MEMORANDUM FOR: J. F. Stolz, Chief, Operating Reactors Branch #4, DL  
FROM: P. C. Wagner, Project Manager, Operating Reactors Branch #4, DL  
SUBJECT: FORTHCOMING MEETING WITH DUKE POWER COMPANY (DPC)  
Time & Date: 9:00am-2:00pm, October 9, 1981  
Location: Phillips Building, Room P-422  
Bethesda, Maryland  
Purpose: To discuss the broken thermal shield bolts in Oconee Unit 1.

Re: Oconee Nuclear Station  
Docket No. 50-269  
RO-269/81-11, Supplement 2

Thermal Shield Bolt Failure Supplementary Information

SUBJECT: REQUEST FOR LPMS REPORT AND NEUTRON NOISE DATA

FIGURE 2  
LOWER THERMAL SHIELD  
STUD DESIGN

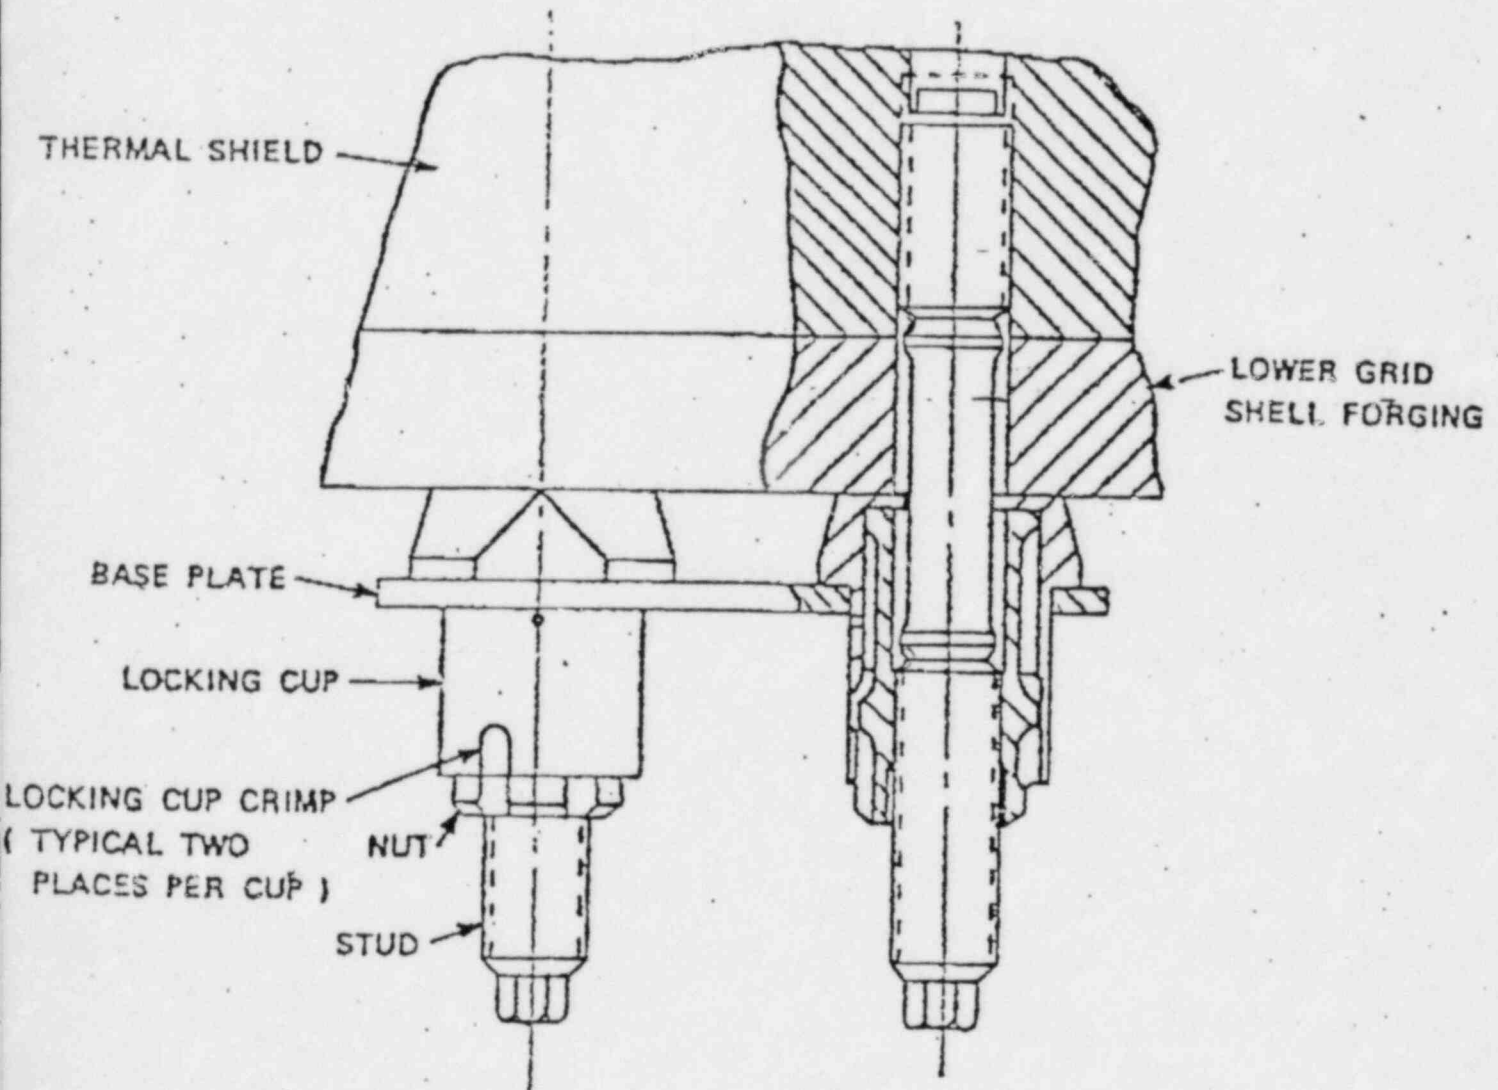
At the present time, redesign of the lower thermal shield has been completed. All 96 bolts and locking clips will be replaced with stud and nut assemblies as shown in Figure 2 attached. The assembly consists of two studs with a baseplate so that 48 such assemblies will be used. Each stud, nut, locking clip and baseplate is first assembled and the assembly so then installed into the existing threaded holes in the thermal shield. A stud tensioner will then tension the studs and set the nuts. After the tensioning is complete, the locking clip which is welded to the baseplate will be crimped onto the nut at groves machined into the nut. The stud and nut material is Inconel X750 which has been selected because of its availability and stress corrosion resistance and satisfactory experience in FWR environment. The locking clip and baseplate are 304SS.
